MANDATORY SERVICE BULLETIN

DATE: May 2, 1995
Service Bulletin No. 518C
(Supersedes Service Bulletin No. 518B)
Engineering Aspects are
FAA Approved

SUBJECT: Inspection of Thermostatic Bypass Valves

Figure 1.

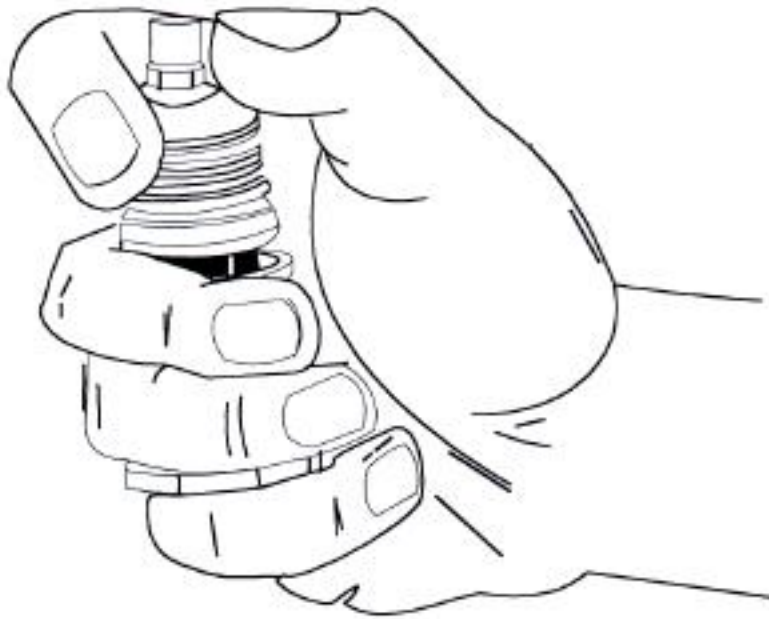
A physical inspection of the crimp nut is required to ensure it is seated and solid on the shaft. Separate the seat and retaining nut by holding the valve assembly in one hand and compressing the valve spring with the forefinger and thumb. (See Figure 1.) With the seat and nut separated, grasp the crimp nut with the other hand and attempt to move it. The crimp nut must not move. If the thermostatic bypass valve assembly does not meet this inspection, it must be reworked or replaced immediately.

Rework of the thermostatic bypass valve can be accomplished by following the procedure in Service Instruction No. 1423. Although Service Instruction No. 1423 refers only to P/N 75944 thermostatic bypass valves, for the purpose of this rework it applies to all thermostatic bypass valves specified above.

After rework, the thermostatic bypass valve must be reinspected annually until replacement.
